Changed item

FCC ID: PP4PX-600

< Picture 1.>

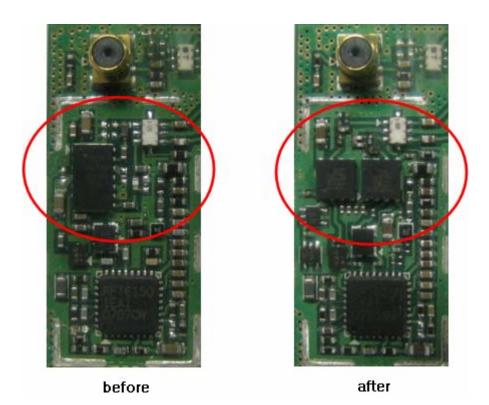
<Before> Picture1 : dual PAM is applied

<After> Picture2 : Cellular -CDMA and US-PCS PAMs are applied to the board respectively.
